Report to the Future Melbourne (Planning) Committee

Planning Permit Application: TP-2020-12 550-558 Spencer Street, West Melbourne

18 August 2020

DELEGATED PLANNING APPLICATION REPORT

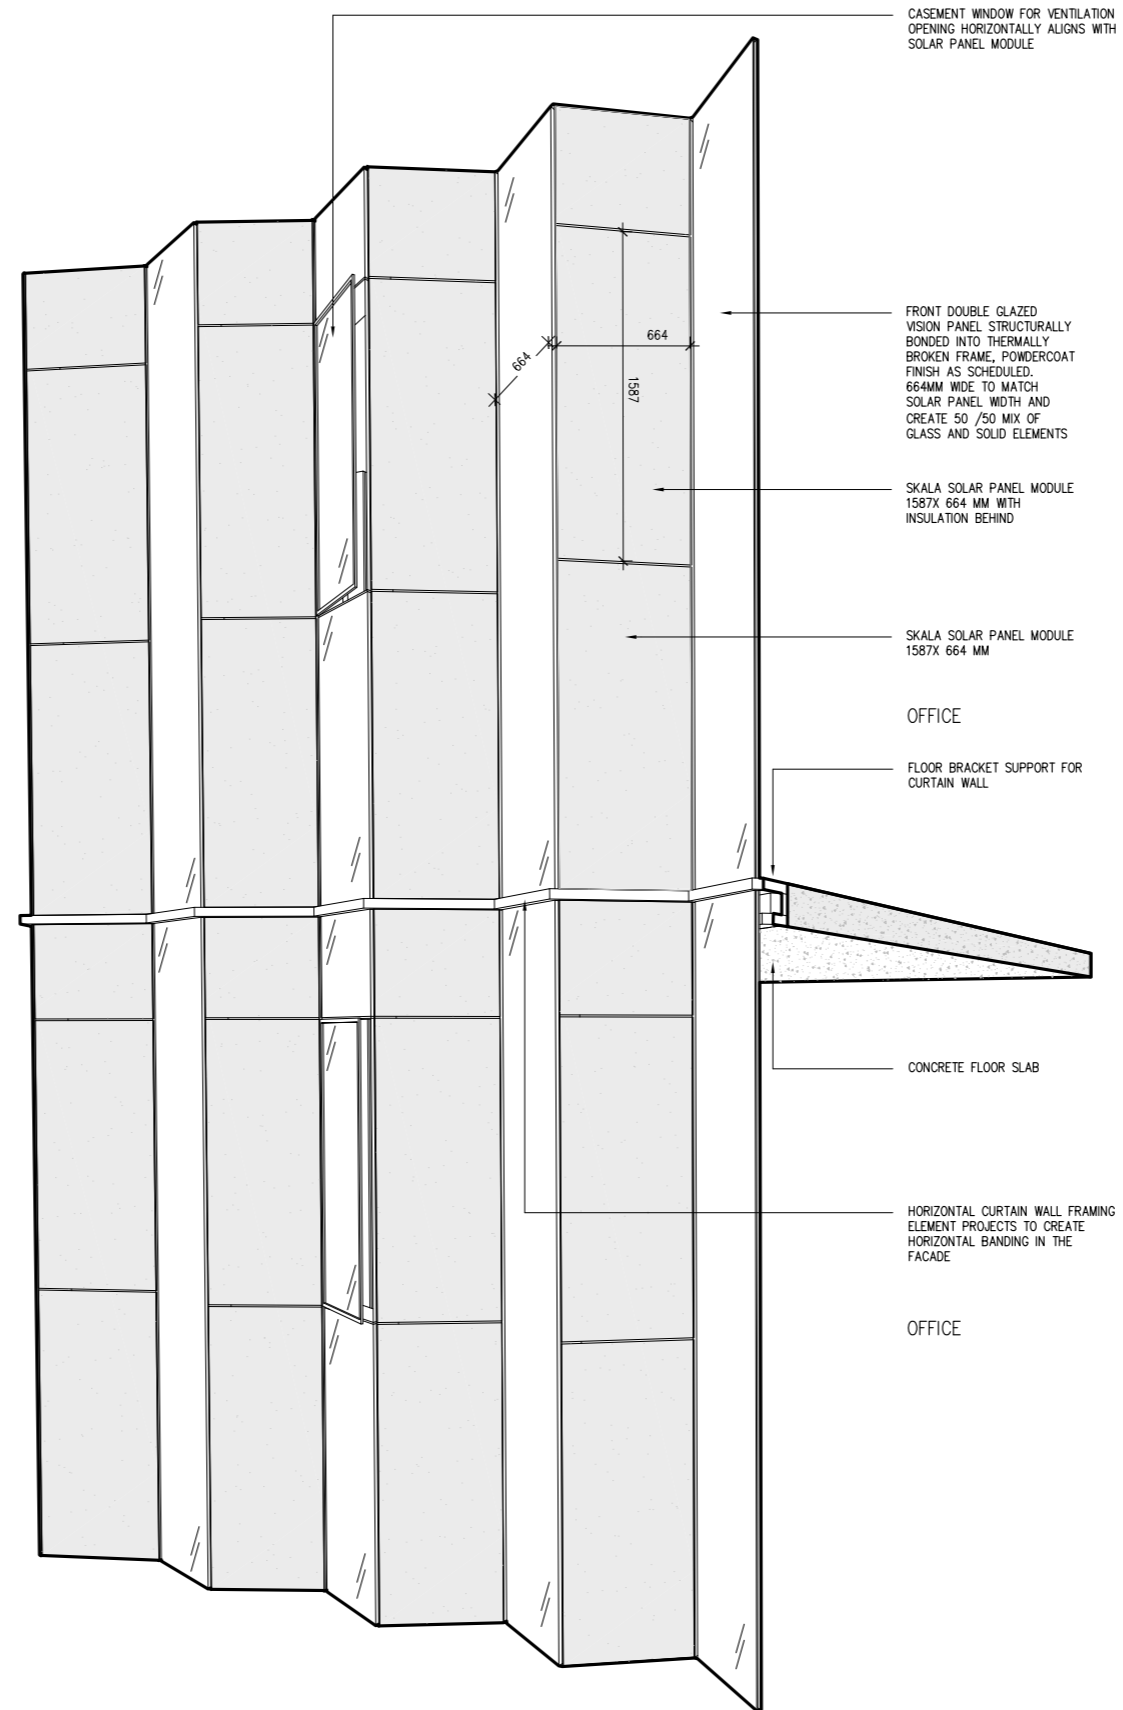
- **Confirm area calculated for FAR detailed in development summary. FAR should be inclusive of all enclosed areas, services, lifts, car stackers and covered balconies. It appears that the cover balconies haven't been included in the calculation of level 1.**

The garden area on level 01 on the Spencer Street frontage is not trafficable and therefore not calculated in the FAR.

ELEMENTAL DETAIL - TOWER FACADE SECTIONAL AXONOMETRIC

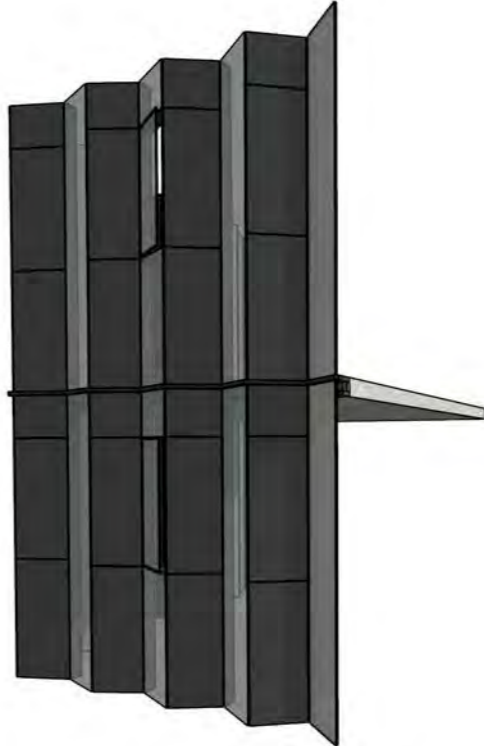
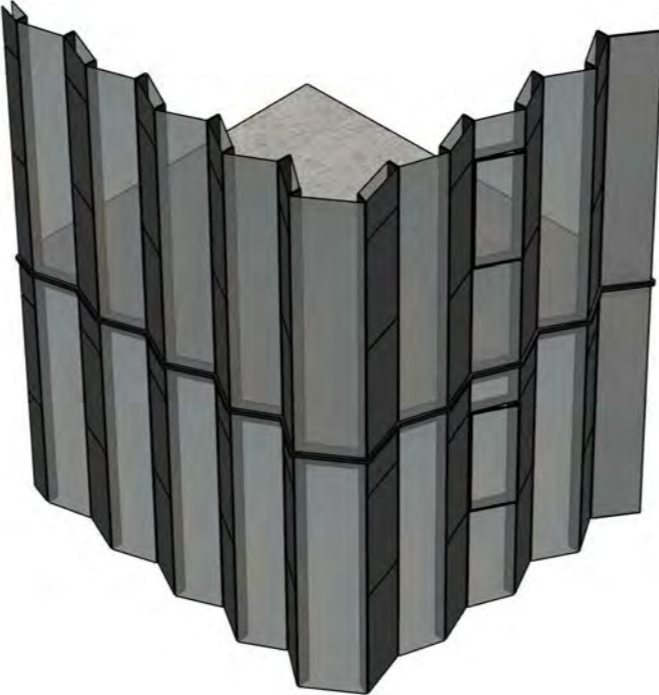
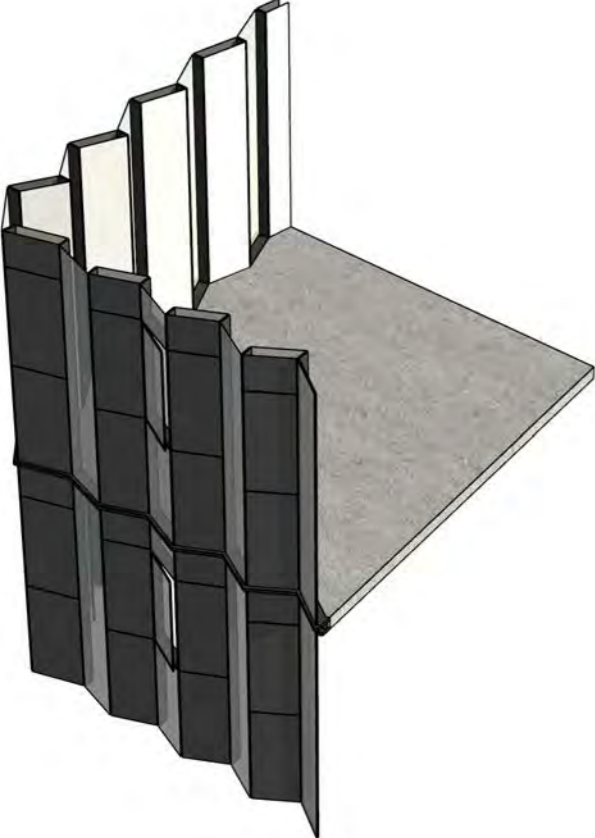
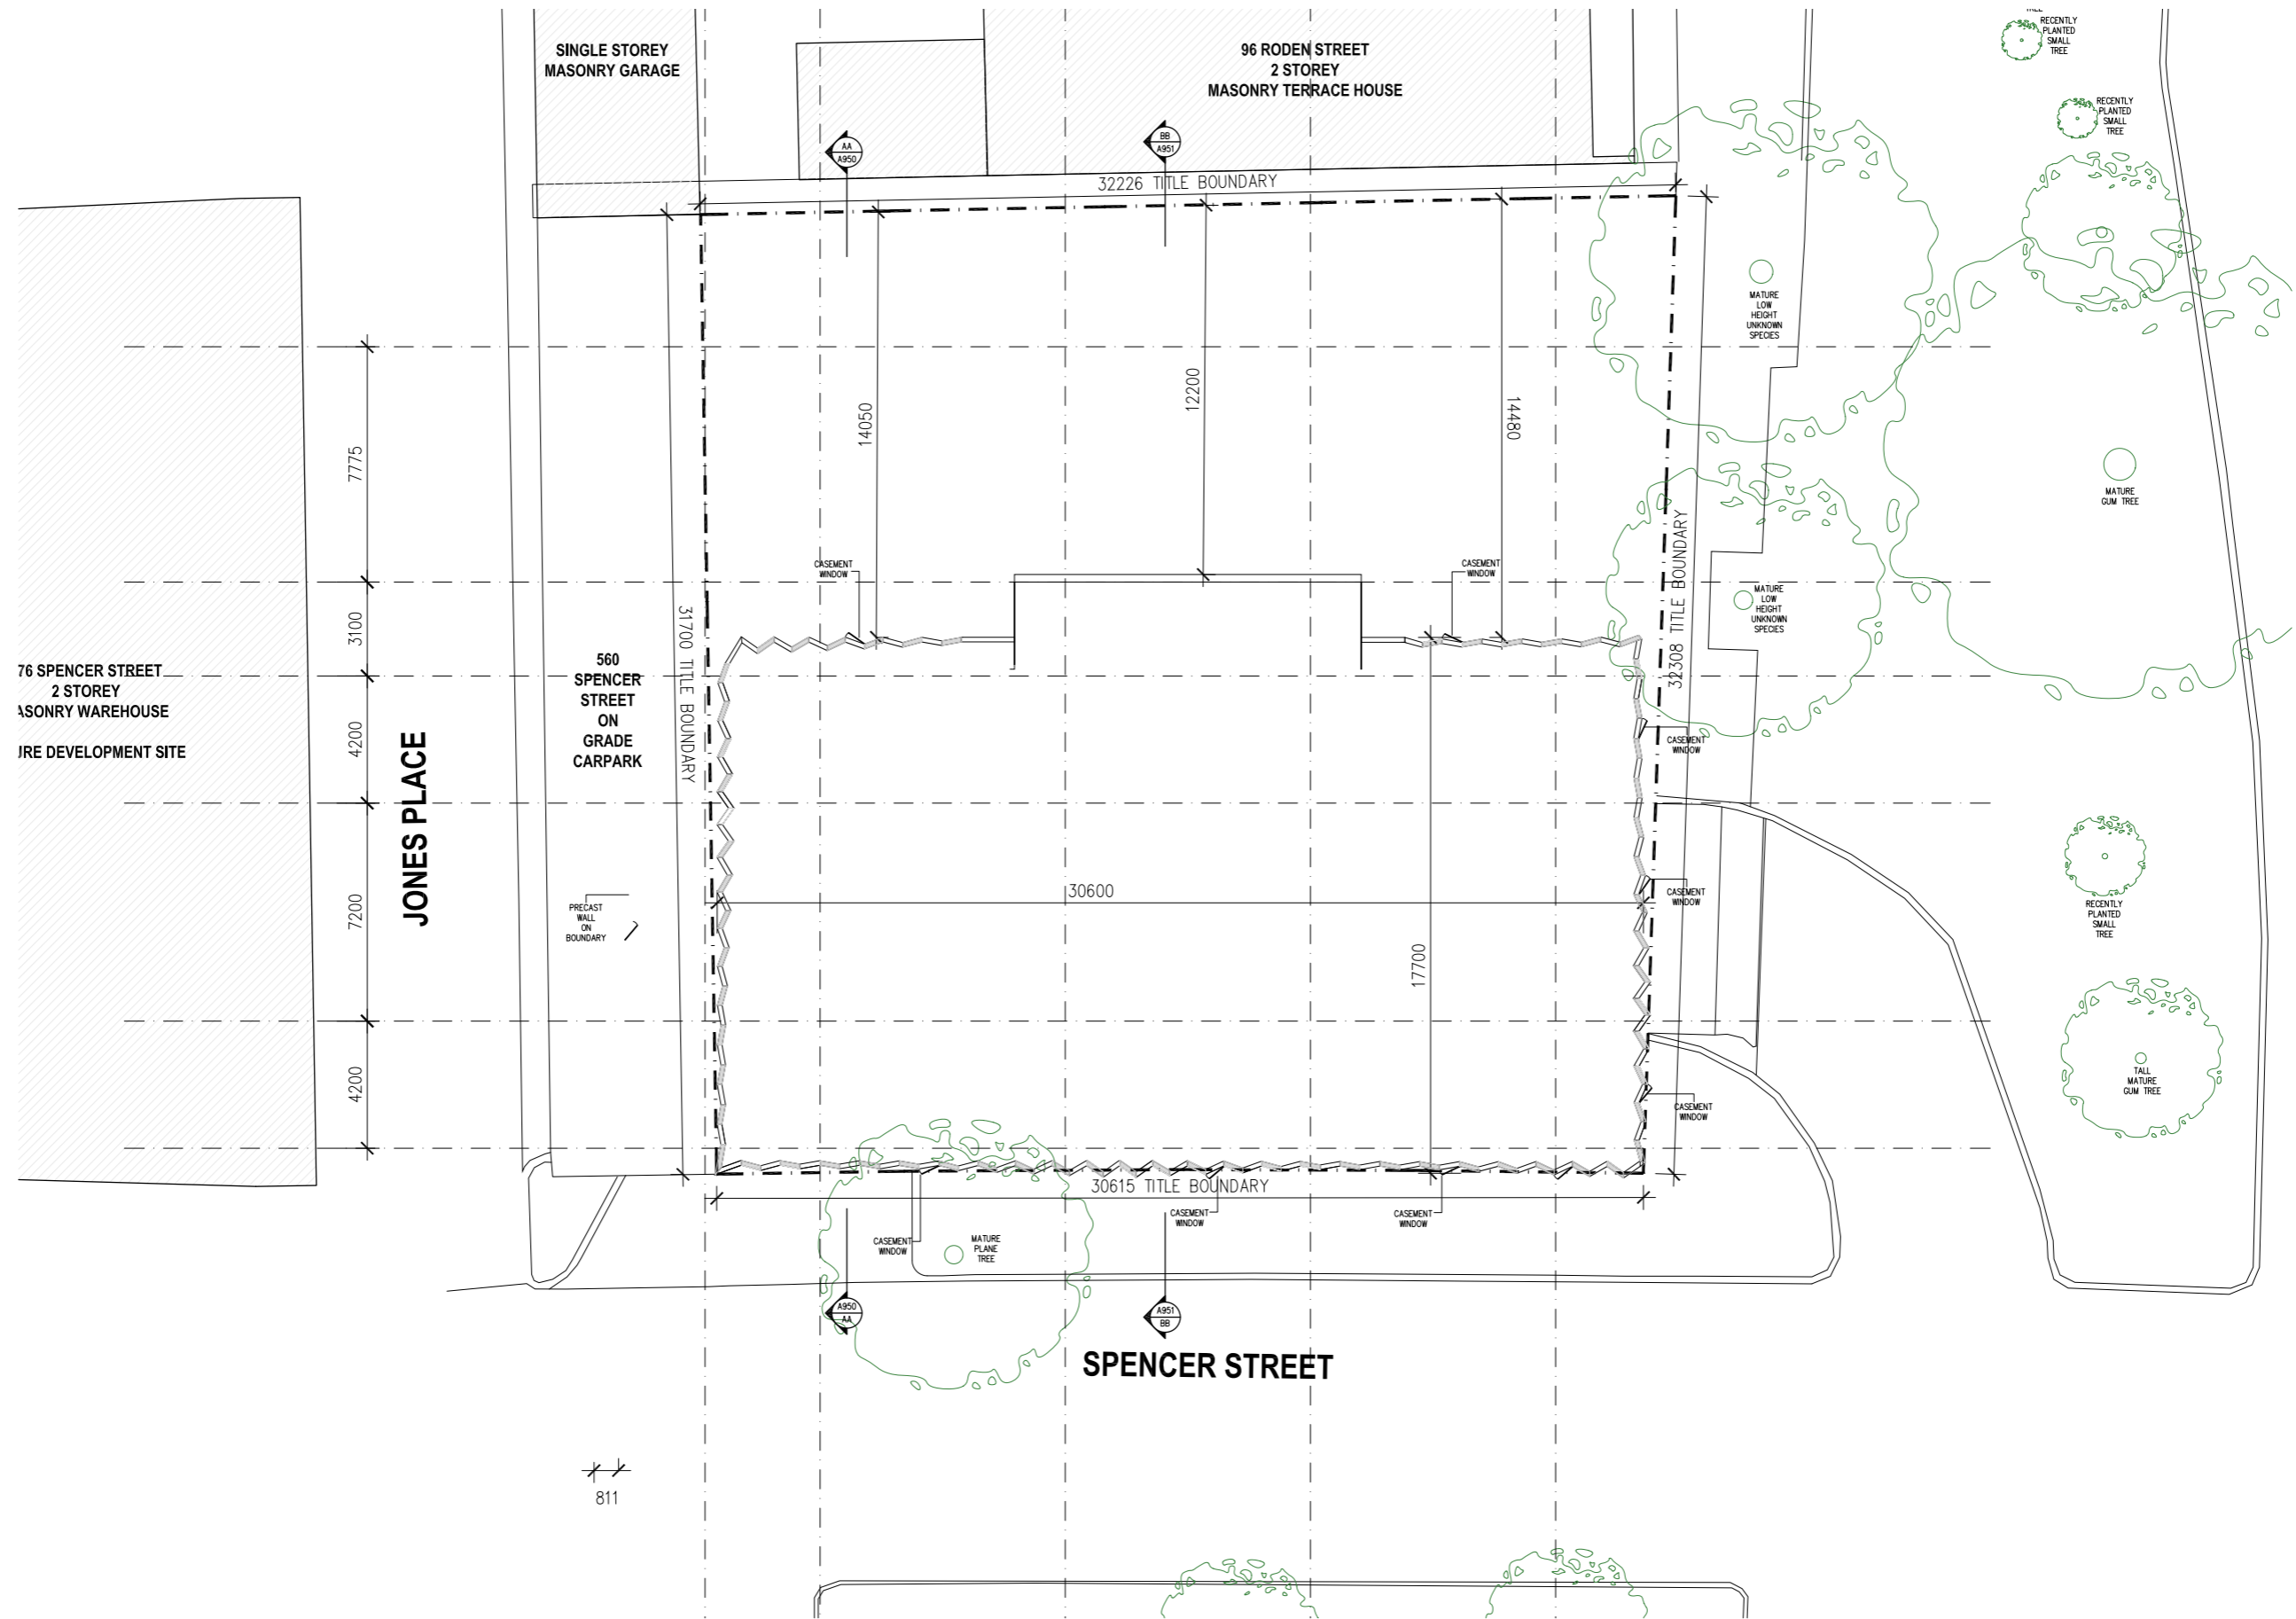
1. Overall the proposed form is supported, however we reiterate the comments from our urban design team regarding the verticality of the facade and how this presents. A revised treatment to the eight storey form should reduce the emphasis on height of this element and break up the vertical form. It is acknowledged constraints due to the solar PV facade may restrict options to address this however improved treatment is required.

2. An improved response is required for the ground floor interface at Spencer Street and partially Roden Street. The proposed materials and finishes for the two-storey element is supported and doesn't require further changes. As advised either the vehicle entry and substation should be rationalised or an improved design response provided. The revised ground floor treatment should be reflective of the immediate heritage context, integrating masonry elements and window forms consistent with the broader area.

The design of the facade in this area and detailing of materials have been revised to introduce a masonry material reflective of the buildings within the surrounding context. Masonry is also brought through the design of the street frontages to better pronounce the solid vs void openings. We have kept the corner of Roden and Spencer visually open with glass to ensure a high level of presence to the streetscape and clear aperture from inside to outside the tenancy.

Masonry to facade

Change to tilt panel door

Substation door as louvered black doors.

New masonry portions to streetscape facade

Figure 5 – Proposed eastern elevation as per advertised plans

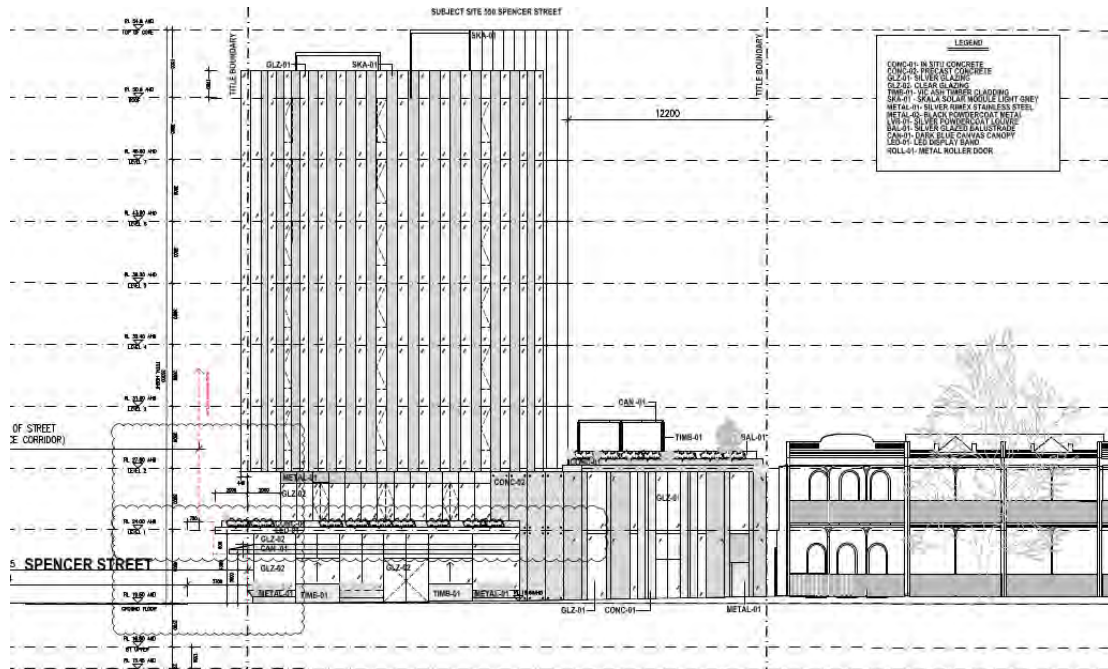
Development directly to the north-east of the site along Roden Street consists of fine grain terraces of two storeys. Opposite the site at 512-544 Spencer Street, an eight storey (27.5 metres RL 47.6) development has been approved by the Minister (Planning Permit PA1600194) and the development has a street wall height of four storeys to Roden Street.

The approved nine storey form has a 12 metre setback between adjoining dwellings on Roden Street; this has been achieved by predominately focusing building mass to the less sensitive interface of Spencer Street. This demonstrates that there is contextual support for increased height in the immediate surrounds given the transitional nature of the area, particularly for properties with a frontage to Spencer Street.

The proposal provides a sympathetic response to the immediate context which straddles a strategic preference for higher density development along Spencer Street whilst respecting existing low rise residential development. The proposal is considered to satisfy the design objectives and built form outcomes of proposed Schedule 72.

Figure 6a – Excerpt of advertised level 1 plan showing proposed encroachment

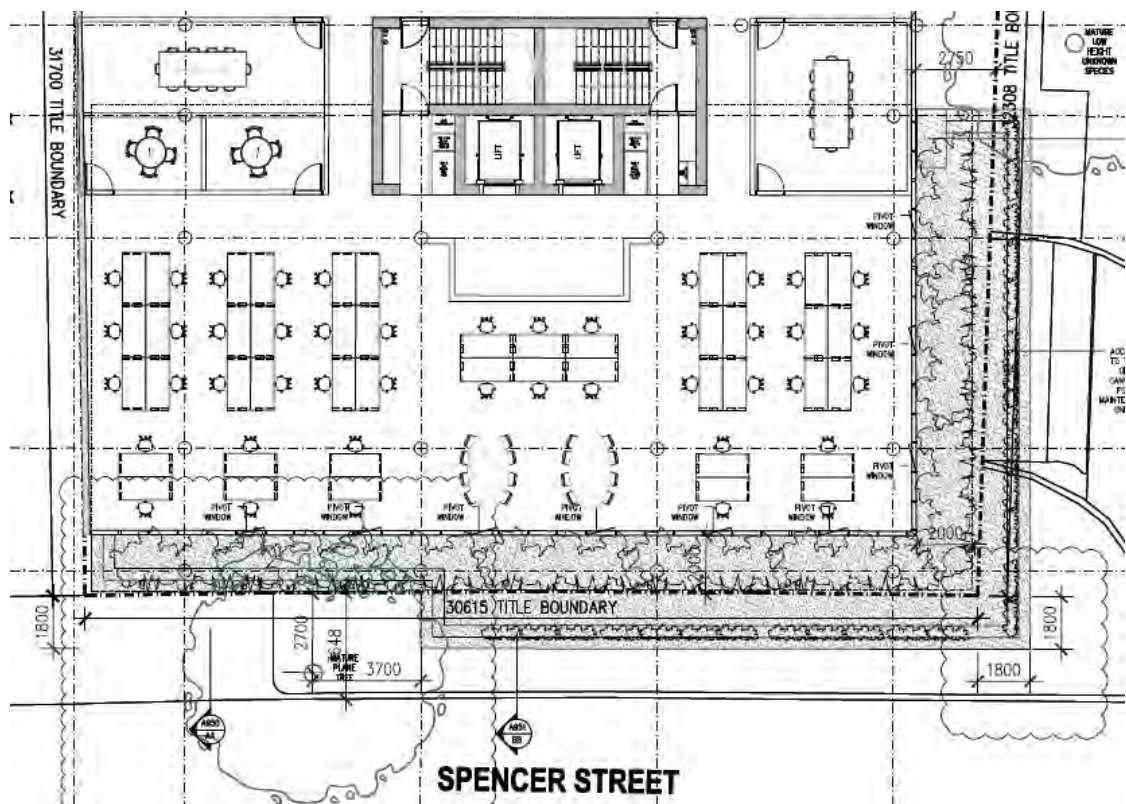
The proposed green roof for a depth of 1.8 metres and the southern façade for a maximum depth of 0.4 metres will project over the title boundary. The applicant contends that these encroachments are minor and advised that these serve to break up the mass of the tower and provide a garden presence to the streetscape.

Clause 7 of Council's Road Encroachment Guidelines outlines the relevant performance measures for encroachments over Council land. The proposed encroachment is not considered to generate a public benefit or provide visual interest above what is being provided on site. The proposed projection may provide some weather protection; however, this is not considered necessary due to the ground level canopy provided. On this basis, a condition is recommended requiring the removal of any features, including building façades, which project beyond the title boundary.

Clause & Objective	Standard Met	Objectives Met
 <p data-bbox="225 1176 774 1214">Figure 9 – Excerpt of overlooking diagram from advertised plans</p>

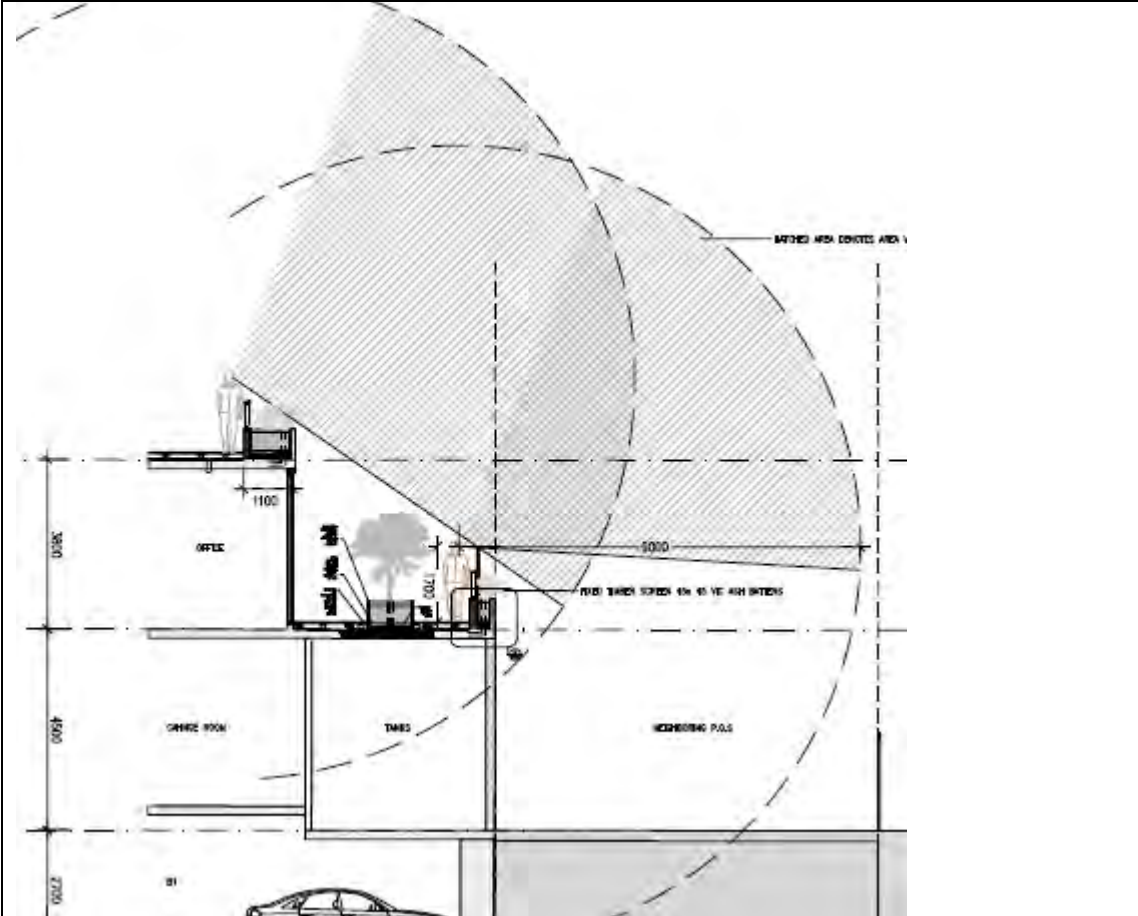
Clause 55.04-4 - North facing windows objective - Standard B20	N/A	N/A
N/A		
Clause 55.04-5 - Overshadowing open space objective - Standard B21	Complies	Yes
<p>The development will result in minimal overshadowing of the adjoining property between 1pm and 3 pm. The extent of overshadowing is limited due to the northern orientation of adjacent secluded private open spaces. It is noted that these areas are also overshadowed by existing structures on site and other buildings in the immediate vicinity.</p> <p>Due to the inner city location of the site and narrow allotments, compliance with Standard B21 is difficult to achieve and on balance the extent of minor additional overshadowing is considered acceptable.</p>		
Clause 55.04-6 - Overlooking objective - Standard B22	Yes	Yes
<p>Overlooking to secluded private open spaces from the Level 1 terrace will be obscured by 1.7 metre high privacy screens. Overlooking from the Level 2 terrace will be obscured due to the setback provided from adjacent secluded spaces. This is illustrated in the section provided below.</p> <p>Screening measures have not been provided to limit views to the adjacent second floor habitable room window. As such, should a permit issue, a condition should be included requiring the Level 2 roof terrace to be screened</p>
